VALLEY TERRACES FIRE ALARM SYSTEM IMPROVEMENTS
UNIVERSITY OF CALIFORNIA, MERCED
MERCED, CALIFORNIA

ADDENDUM NO. 1
to the
CONTRACT DOCUMENTS
June 11, 2014

1 PROPOSED PLAN - DINING AREA
SCALE: 1/8"=1'-0"

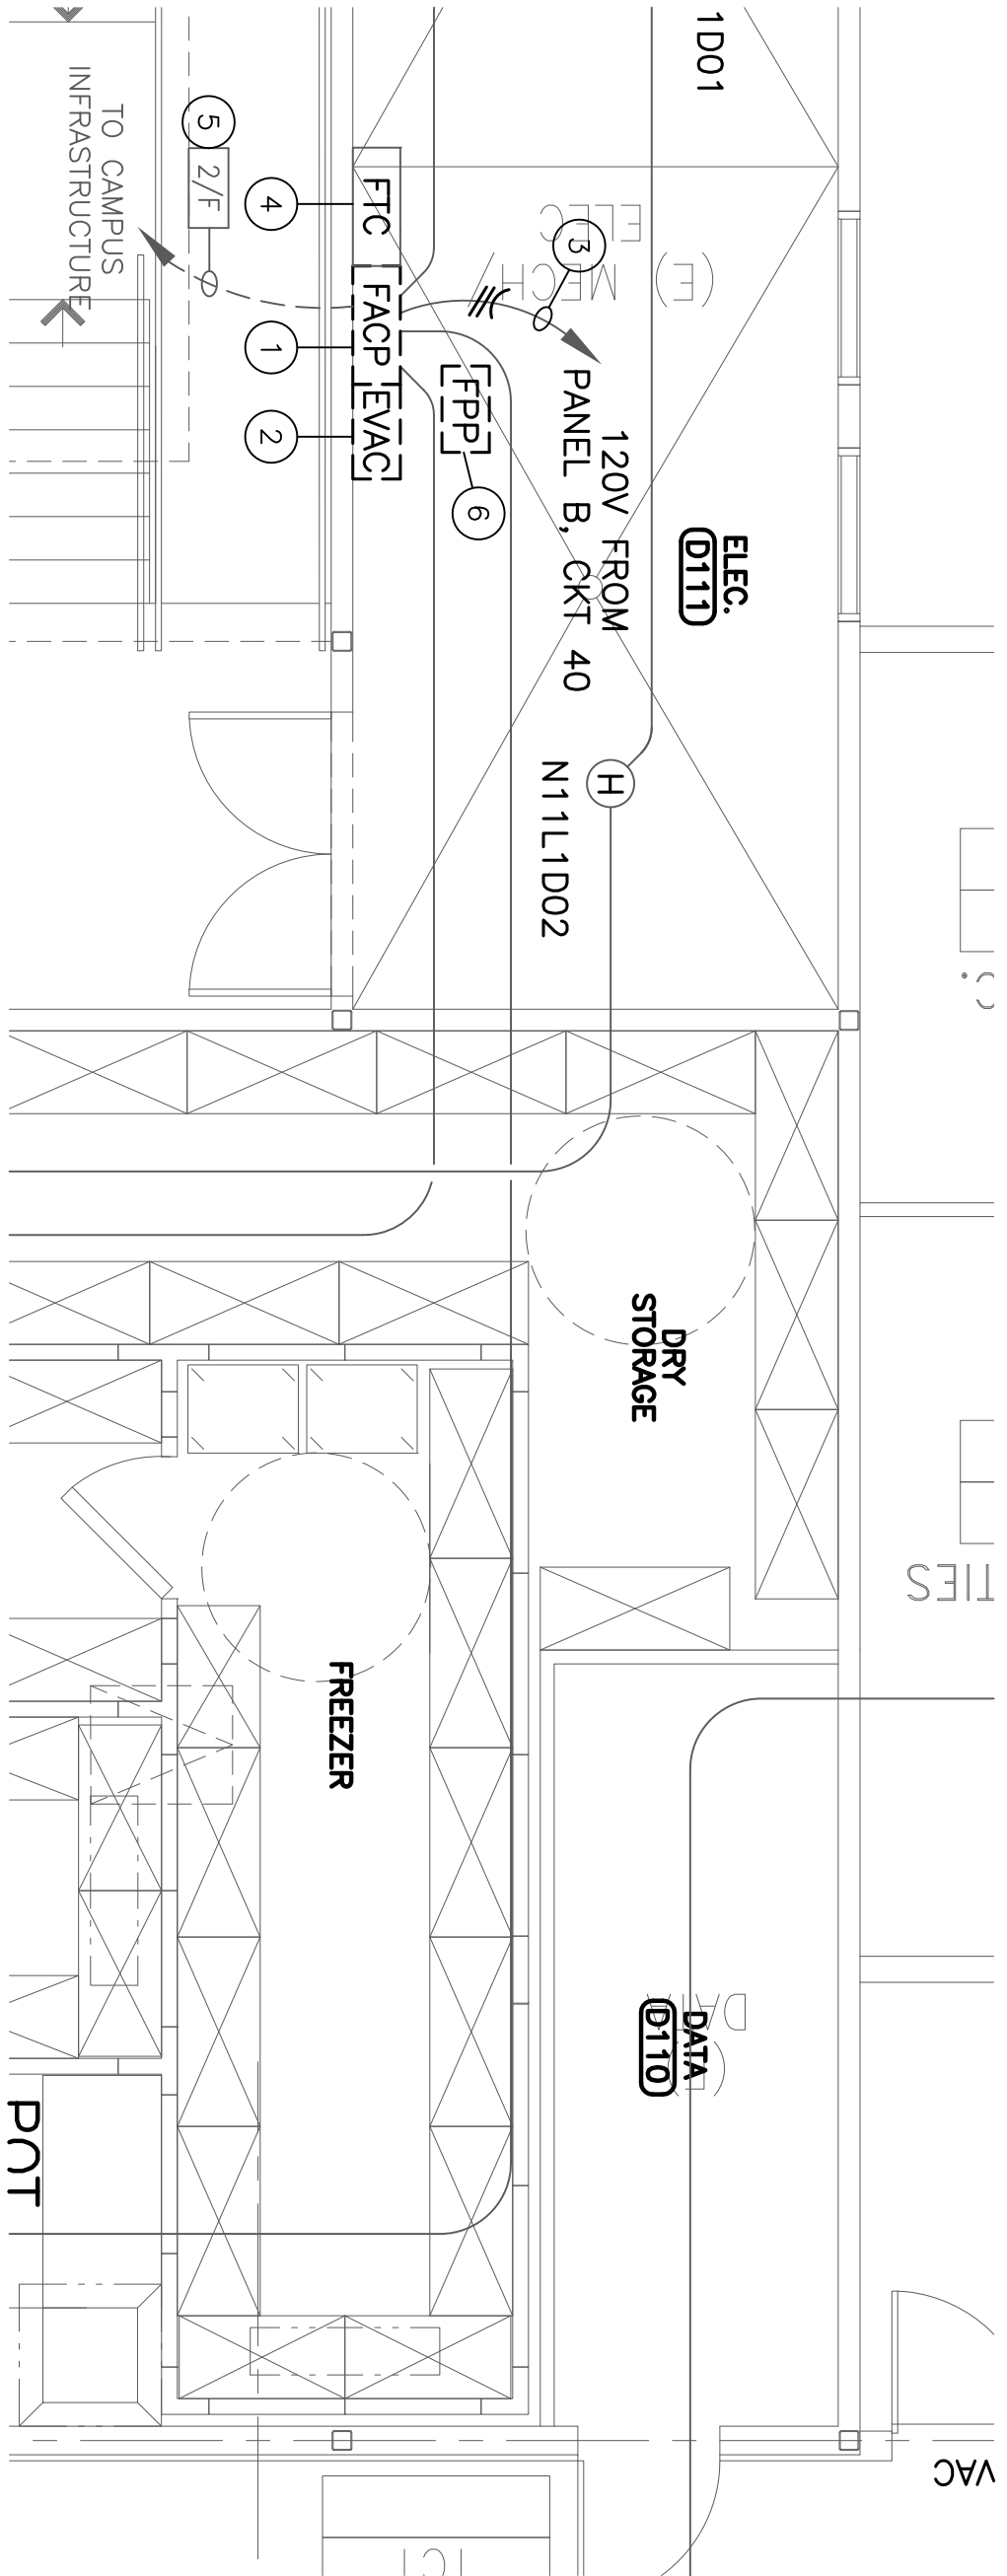
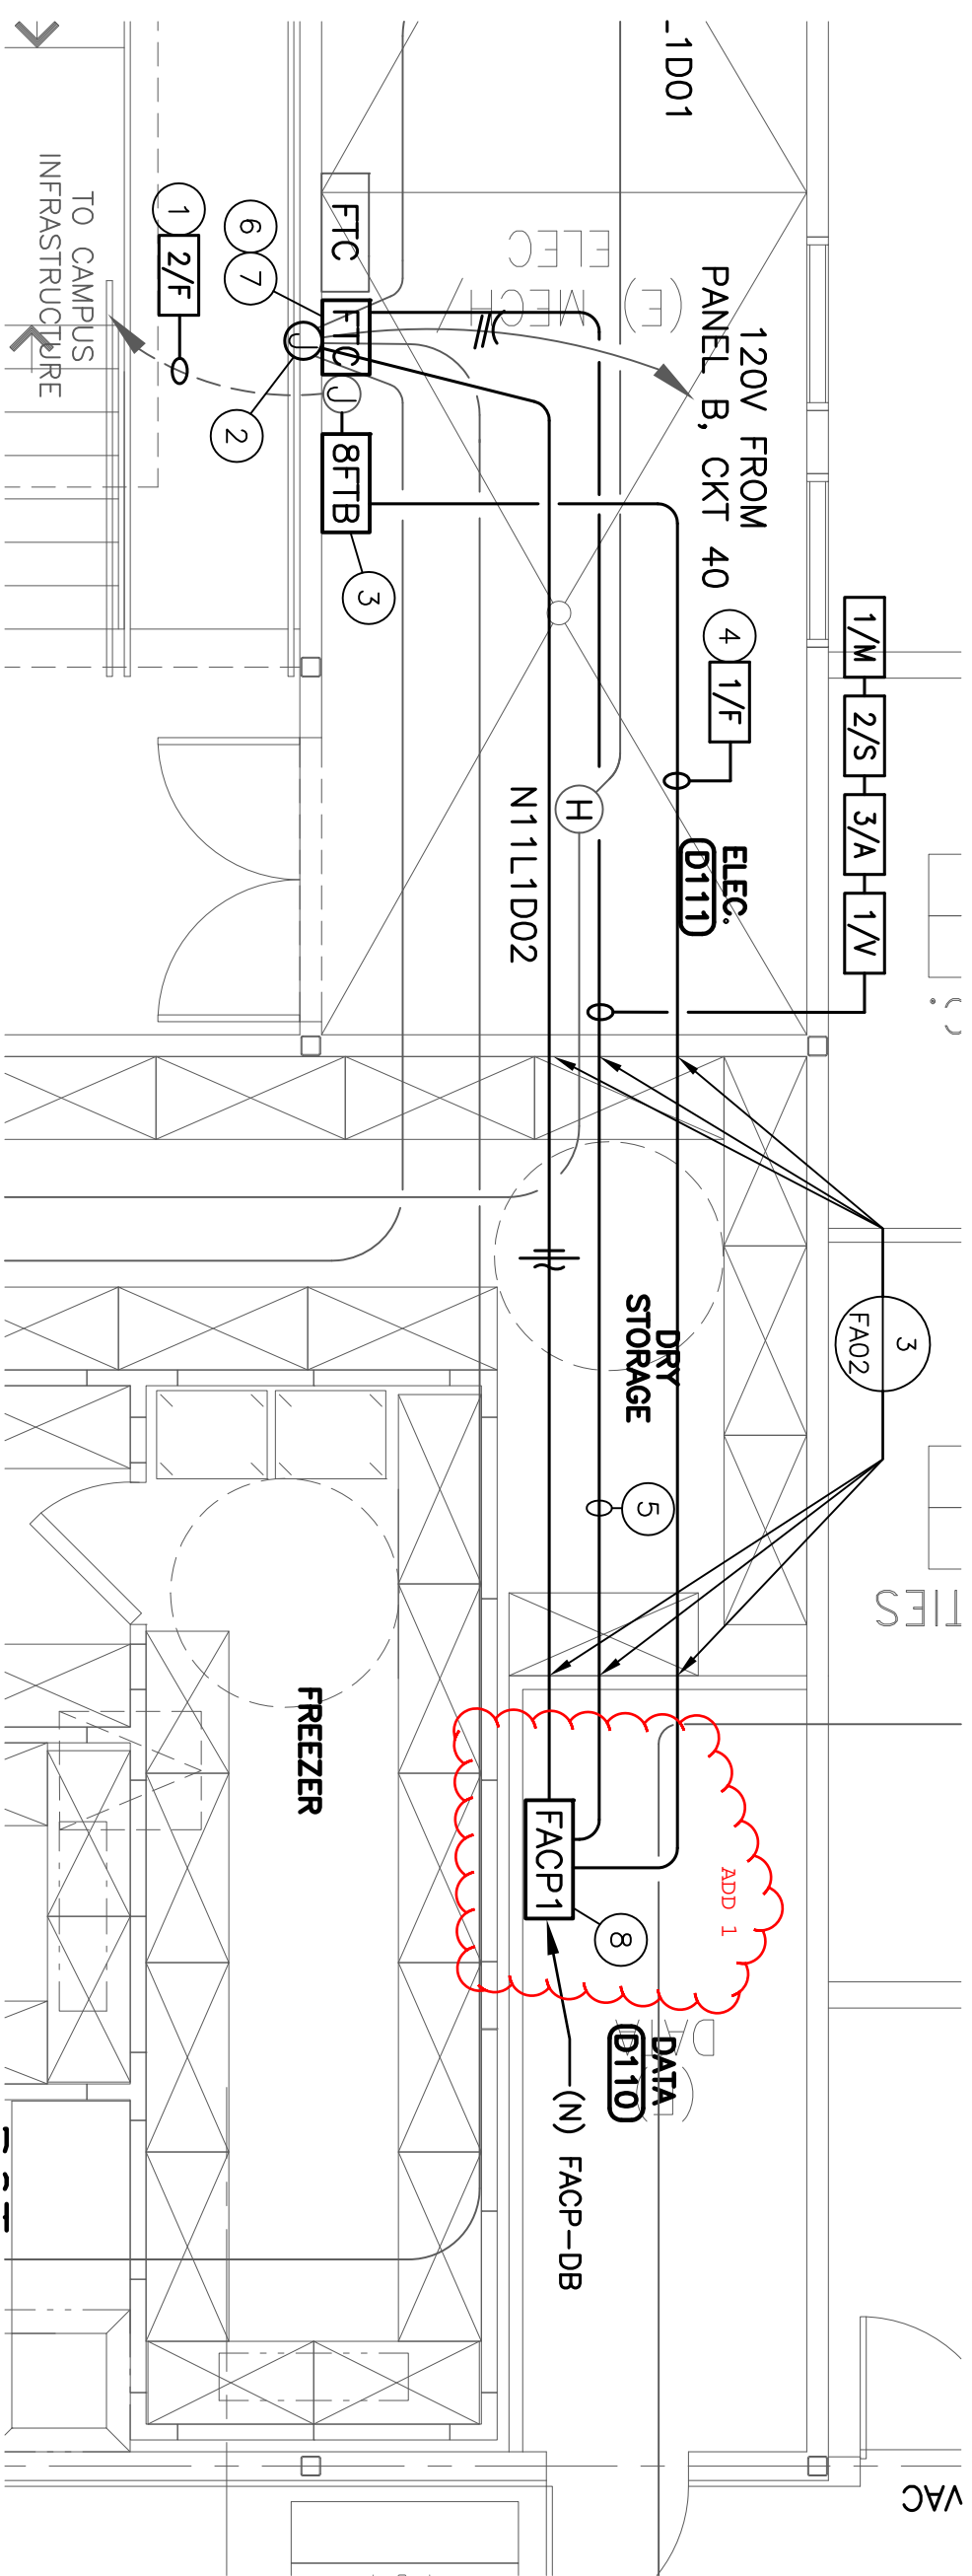
1. **ADD:** (1) smoke detector in the IDF room in Dining. Code requires a smoke detector within 5 feet of Fire Panel.
2. **CLARIFY:** Working in the vault is considered a Confined Space. Contractor must follow Confines Space Entry Procedures.
3. **CLARIFY:** Reuse existing (8) fire panel boxes as FTC.

Annotation 1 - Add (1) smoke detector in the IIF Room 0110. Code requires a smoke detector within 5 feet of the fire panel.
